Below, find the original reviewer concern/question in regular typeface followed by our response in italic typeface. This response is written in anticipation of making all corrections to a manuscript as stated. Therefore, we make statements such as 'we changed' or 'we corrected' or 'we modified' in past-tense as if this document were being submitted together with a revised manuscript. It is our intent that the revised manuscript will read exactly as suggested here. We have also included references to the other review.

This paper details a study using the Hillslope River Routing Model (HRR) to better constrain surface meltwater routing on Greenland, improving on results that only use surface mass balance models. This is a good example of taking more advance techniques used in hydrology and applying them to glaciology, something which can greatly benefit the field.

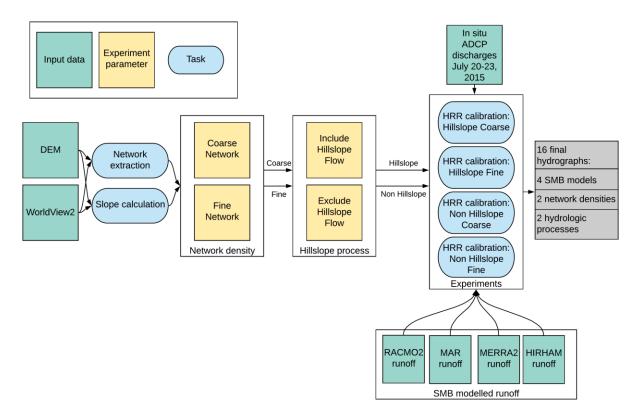
Figure 1: The middle 4 squares could be laid out in a clearer way. Why does including or excluding hillslope flow have a 'yes' or 'no' but there is no differentiation between coarse and fine network?

Good question. We have streamlined the figure as follows, which hopefully communicates more clearly.
